CNL-17-070

Clinch River Nuclear Site
NRC Docket No. 52-047

Subject: Submittal of Supplemental Information Associated with Hydrologic Engineering in Support of the Clinch River Nuclear Site Early Site Permit Application

Supplemental Information Regarding Site Safety Analysis Report Section 2.4, "Hydrologic Engineering"

Figure 2.4.3-23. Melton Hill Reservoir Volume versus Elevation

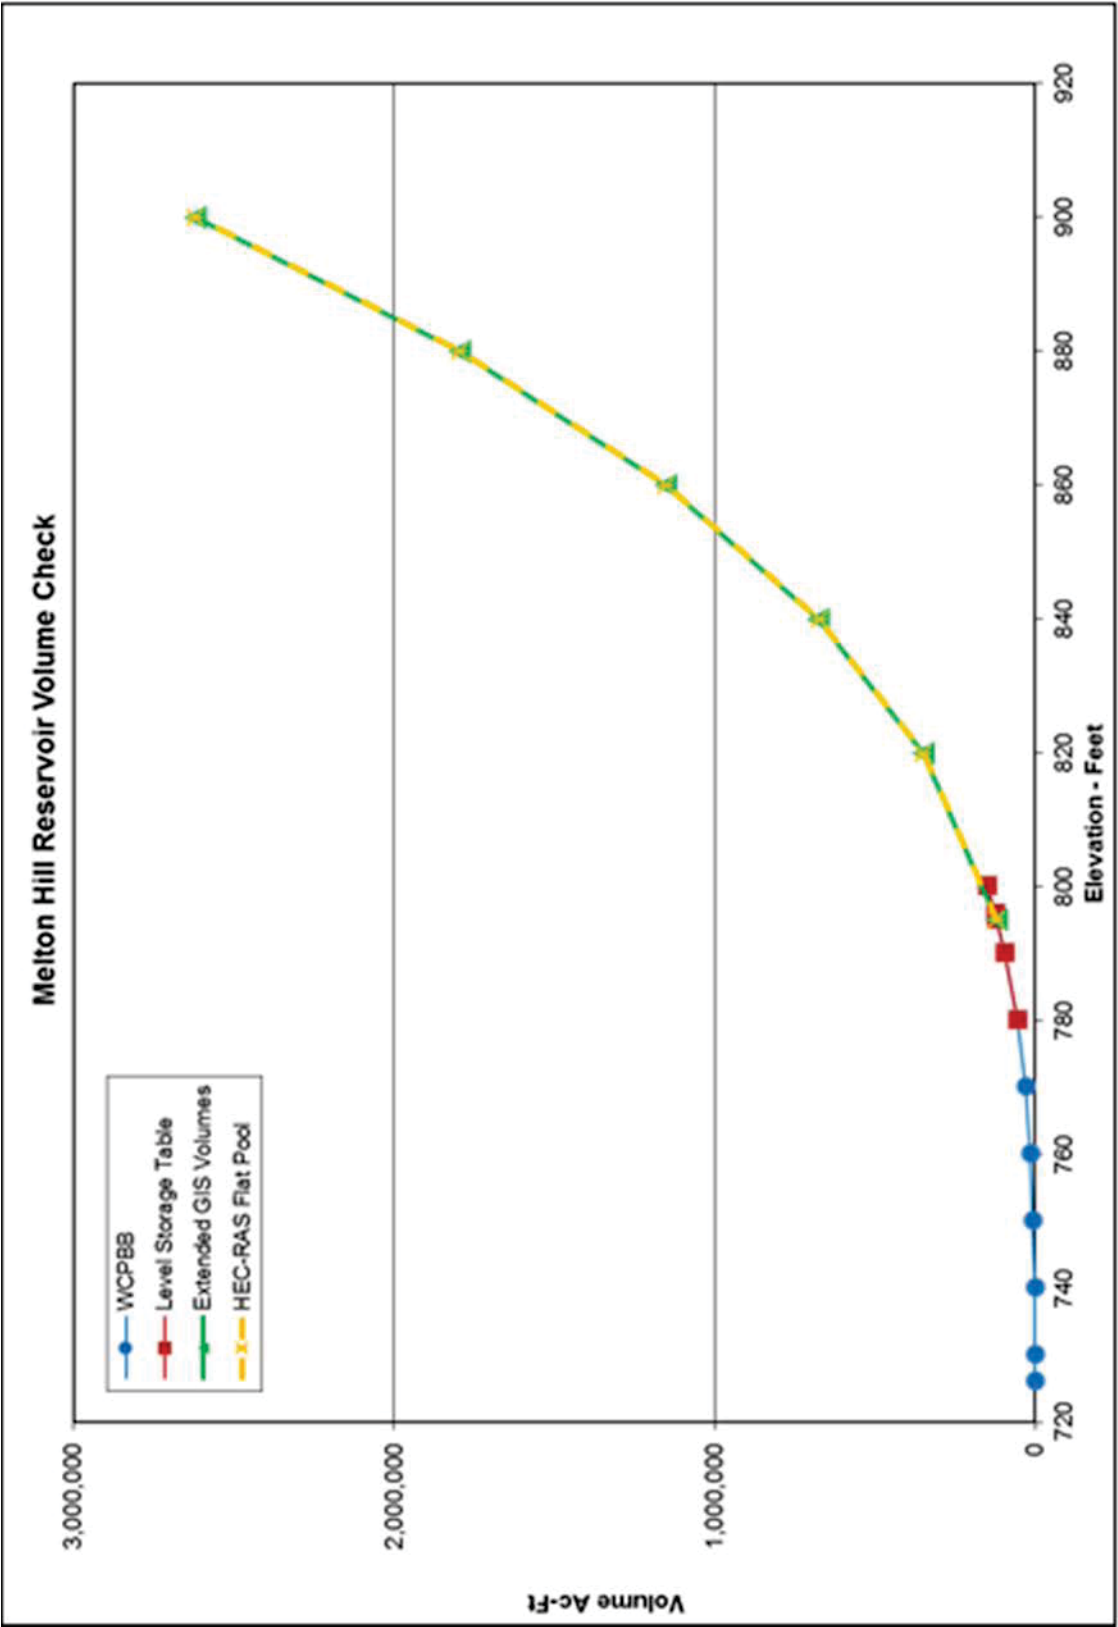
SSAR Subsection 2.4.3.4.3, "Stream Course Model Geometry Development and Calibration," and Subsection 2.4.3.4.4, "Design Storm Implementation," are being revised to add sufficient detail on the development of the HEC-RAS model, including a discussion of ineffective flow, impact of new fill on storage capacity, and new fill above PMF and away from the conveyance channel. In addition, figures depicting the reservoir storage curves and reference to the reservoir storage curves are being included in Subsection 2.4.3.4.3. See the markup provided in SSAR Subsections 2.4.3.4.3, first, second, fourth, and fifth paragraphs and 2.4.3.4.4, first and fifth paragraph, and new Figures 2.4.3-22, "Norris Reservoir Volume versus Elevation," 2.4.3-23, "Melton Hill Reservoir Volume versus Elevation," and 2.4.3-24, "Watts Bar Reservoir Volume versus Elevation," in Attachment 3.

Figure 2.4.4-5. Seismic Inflow Hydrographs for 500-Yr June Flood Event – Norris Dam

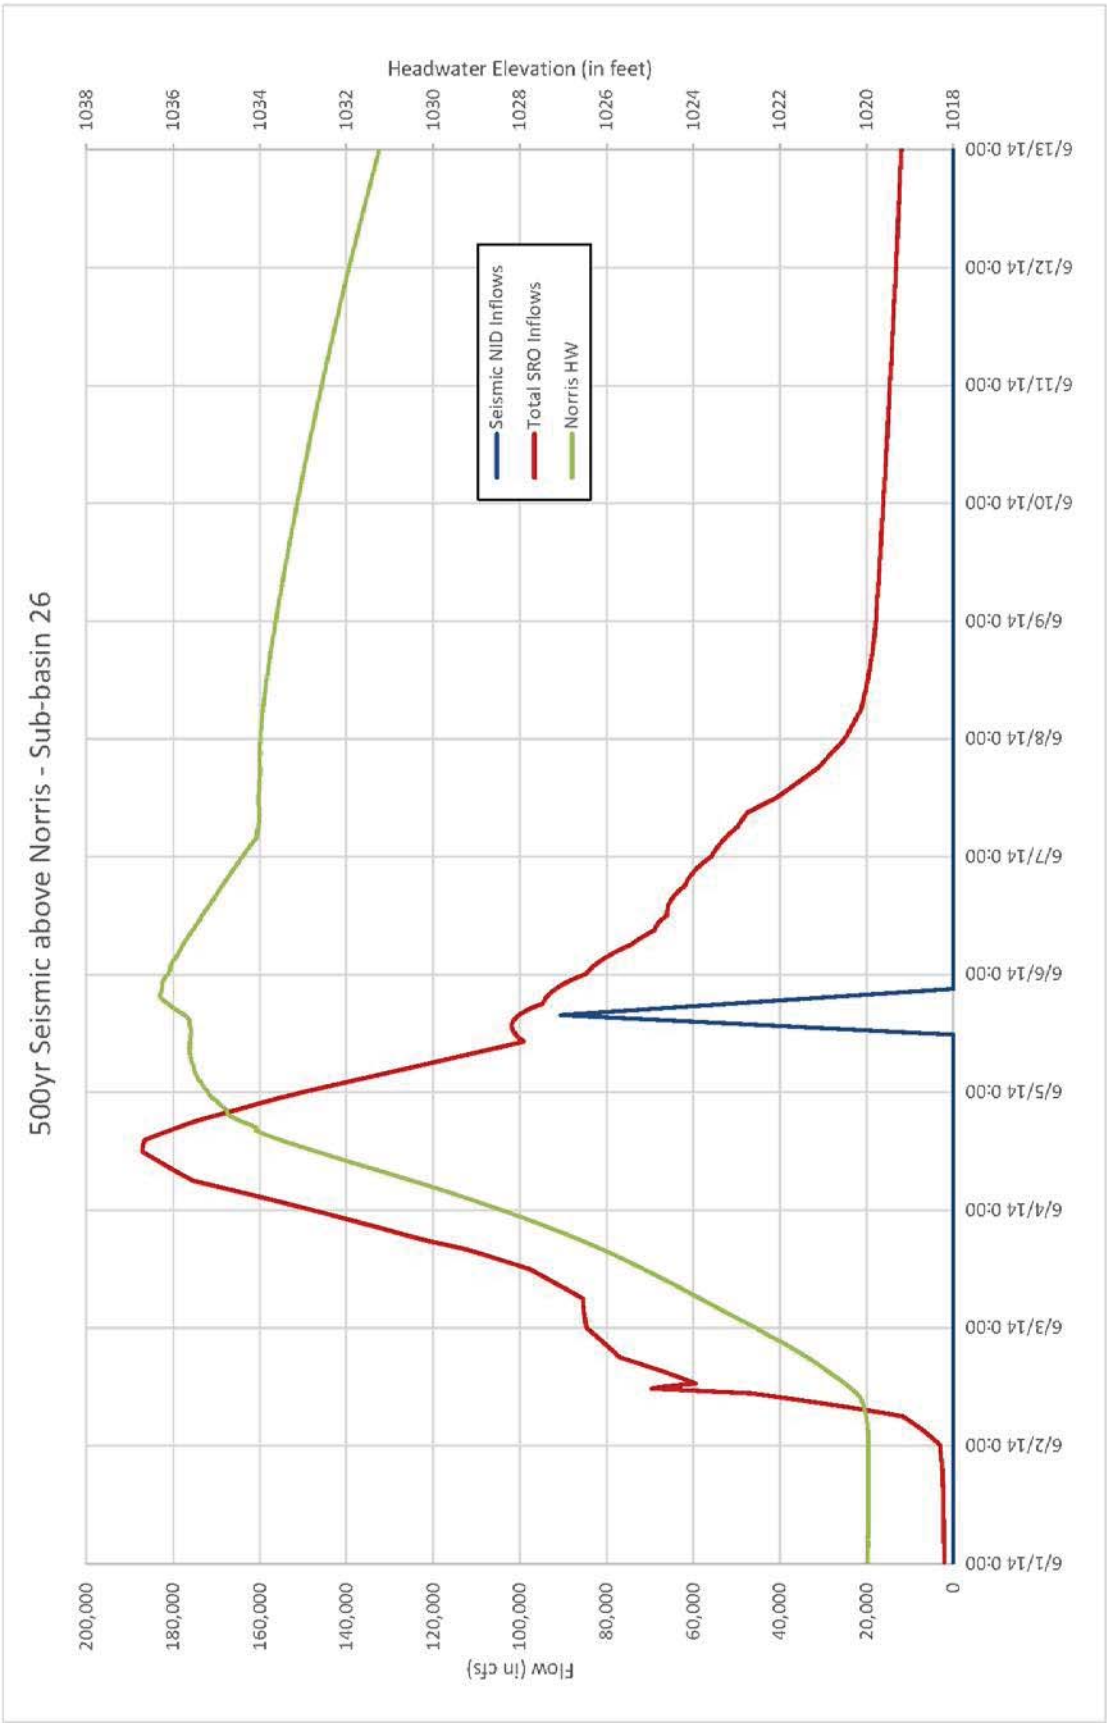
The seismic NID inflow hydrographs, Figure 2.4.4-5, "Seismic Inflow Hydrographs for 500-Yr June Flood Event - Norris Dam," Figure 2.4.4-6, "Seismic Inflow Hydrographs for 500-Yr June Flood Event - Melton Hill Dam," and Figure 2.4.4-7, "Seismic Inflow Hydrographs for 500-Yr June Flood Event - Watts Bar Dam," are being added to SSAR 2.4.4. Reference to the Figures is being added to SSAR Subsection 2.4.4.2.1, "Seismic Failure Analysis," at the end of the sixth paragraph under the subheading "Flood Routing." See the markup in SSAR Subsections 2.4.4 and the new Figures 2.4.4-5, 2.4.4-6, and 2.4.4-7, in Attachment 4.
